Spit Bridge to Neutral Bay
B-Line Road Infrastructure
Submissions Report

Prepared by AECOM and Roads and Maritime Services

Figure 2-1: Allowable traffic movements at the intersection of Spit Road and Stanton Road outside of the AM peak.

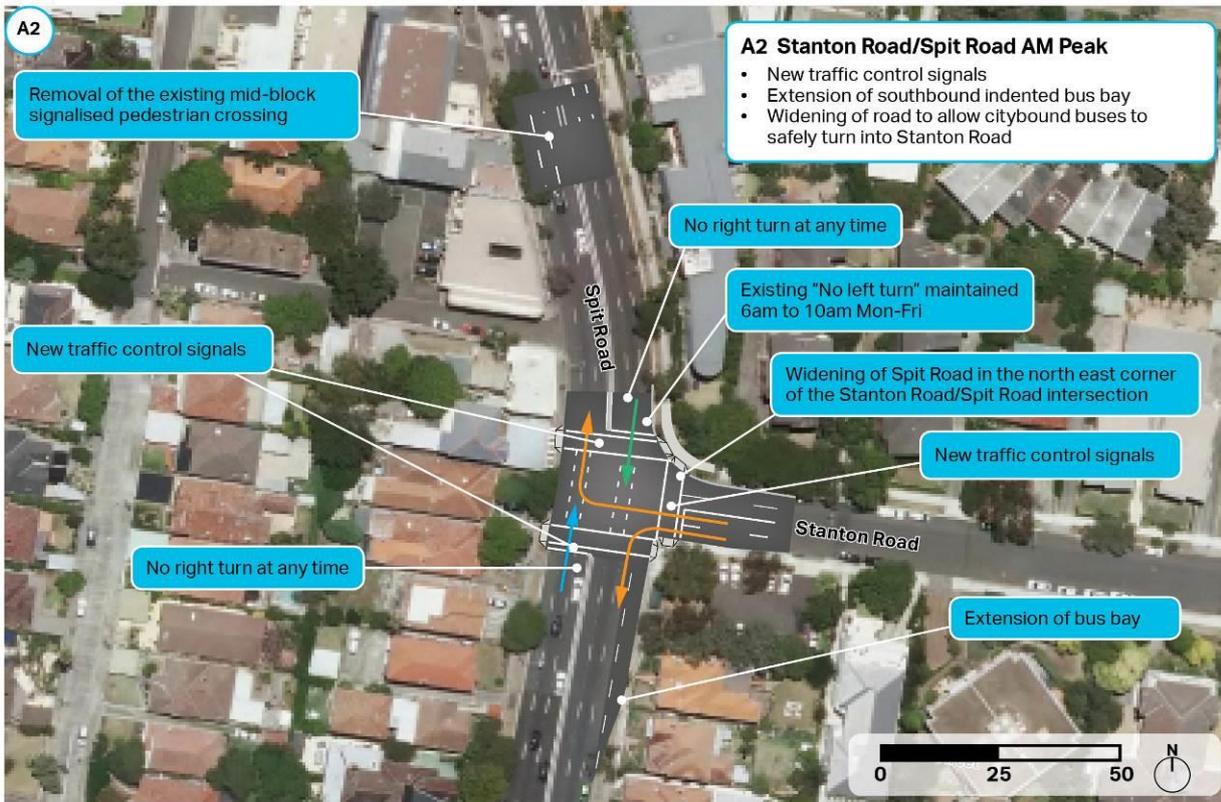
The majority of responses which mentioned Stanton Road were opposed to the proposed new traffic signals. The main concerns within these submissions related to increased traffic on Stanton Road and its associated impacts including, but not limited to, driveway access, property value, road safety and environmental/ health impacts. These are outlined in more detail below.

Figure 2-1 and Figure 2-2 illustrate the allowable traffic movements proposed at the Stanton Road/Spit Road intersection at different times of the day.

The proposal for the traffic control signals at Stanton Road is to provide an additional access point to Spit Road for traffic wishing to turn right (ie head north) from the east side of Spit Road. This is intended to relieve the existing right turn at Awaba Street that is heavily congested at numerous times across the day and at weekends. To achieve this, the existing right turn restriction out of Stanton Road onto Spit Road (outbound) during the PM peak would be removed and a signal-controlled right turn would be introduced. This is likely to result in additional traffic using Stanton Road to access Spit Road outbound. The proposed signals are not expected to introduce additional traffic turning from Spit Road into Stanton Road as the existing left turn restriction in place during the AM Peak would remain, thus maintaining the current restrictions on rat-run vehicles and minimising risk to pedestrians on local roads during this period. The number of vehicles entering Stanton Road from Spit Road outside of the AM peak would not be affected by the proposed traffic signals as this movement is already unrestricted.

Signalised pedestrian crossings would be provided on all three sides of the intersection as shown in Figure 2-1 and Figure 2-2 above. The phasing of the traffic signals would provide 'red arrow' protection for all pedestrian movements when pedestrian buttons have been pushed. The provision of traffic signals would improve the safety of pedestrians who currently have to cross Stanton Road to access the bus stop without signalised protection. The signals would also provide a direct protected crossing point for bus passengers wishing to cross Spit Road to access the bus stop on the eastern side without having to walk to the mid-block pedestrian crossing 70 metres north of Stanton Road.

It is noted that the road verge on the north-west corner of the intersection is not being narrowed and would remain as the standard 3.6 metre width. The road verge at the north-east corner of the intersection is however proposed to be narrowed to allow additional turning room for buses turning into Stanton Road from Spit Road. It is proposed to partially acquire property from 129-133 Spit Road to still provide a standard 3.6 metre wide road verge at the north-east corner.
